Technical Service Bulletin

Cobra Moto, LLC

TSB00716 Clutch Nut Belleville on CX50's

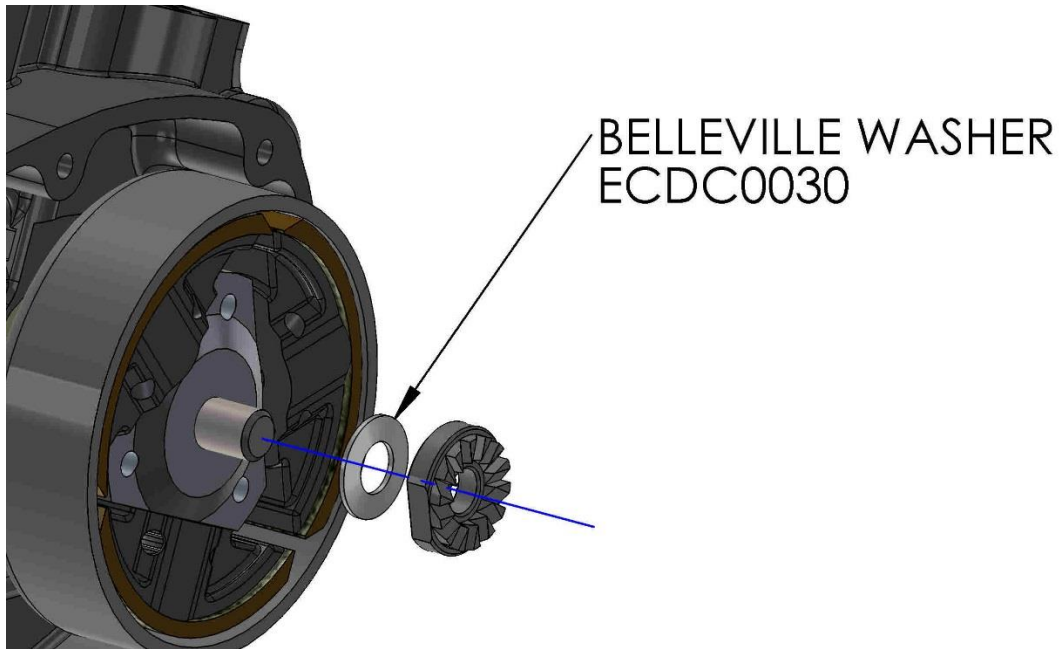
Cobra will begin installing a Belleville lock washer between the clutch arbor and the clutch nut (kick start nut) on the CX50 King and JR models.

It is recommended that the customers install this also.

ECDC0030 is the part number.

As before, torque the clutch nut to 45 ft-lb with red high strength thread lock agent (Loctite 263).
